TELECOMMUNICATION STANDARDIZATION SECTOR OF ITU G.984.3

Amendment 2 (11/2009)

Gigabit-capable Passive Optical Networks (G-PON): Transmission convergence layer specification

Amendment 2:

Figure 10-8 – "Zero-distance" Equalization delay and Time of Day calculations

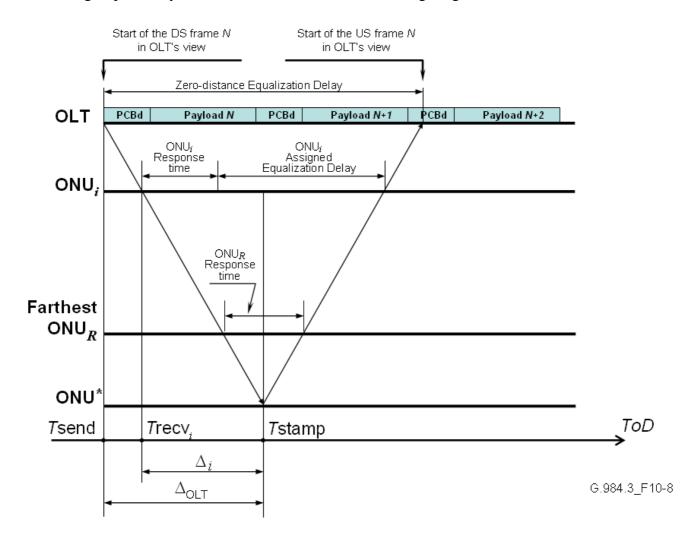
Add the new clause 10.4.6 with the following text:

10.4.6 Time of Day distribution over GPON

Teqd – The "zero distance" equalization delay, equal to the offset between the downstream and upstream frames at the OLT location. The OLT adjusts the equalization delay of each ONU such that, for all ONUs, the start of the upstream frame at the OLT occurs **Teqd** seconds after the start of the downstream frame. See Figure 10-8 below and subclause 10.4.3.3.

Figure VII-2-1/G.984.3: Refractive index difference as a function of operating wavelength

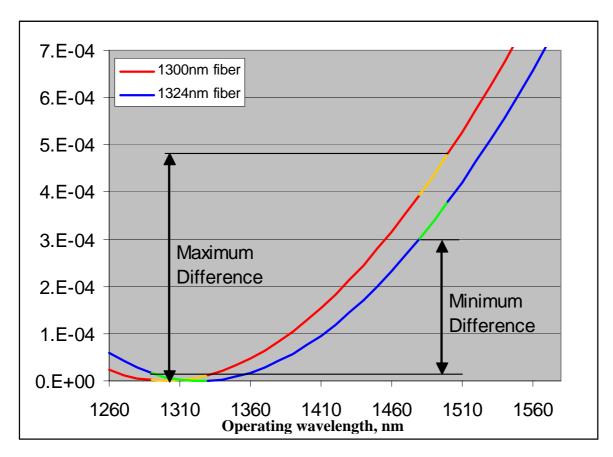
Provide a new informative Appendix at the end of Recommendation with the following text:

The index difference function is graphed for the two extreme cases of G.652 fiber in Figure VII-1, where the zero dispersion wavelengths are 1300 and 1324 nm. Also shown are the wavelength ranges for the "reduced" type G-PON transmitters (1290 to 1330 nm for the upstream and 1480 to 1500 nm for the downstream). The maximum index difference is 0.000481, and the minimum index difference is 0.000285.
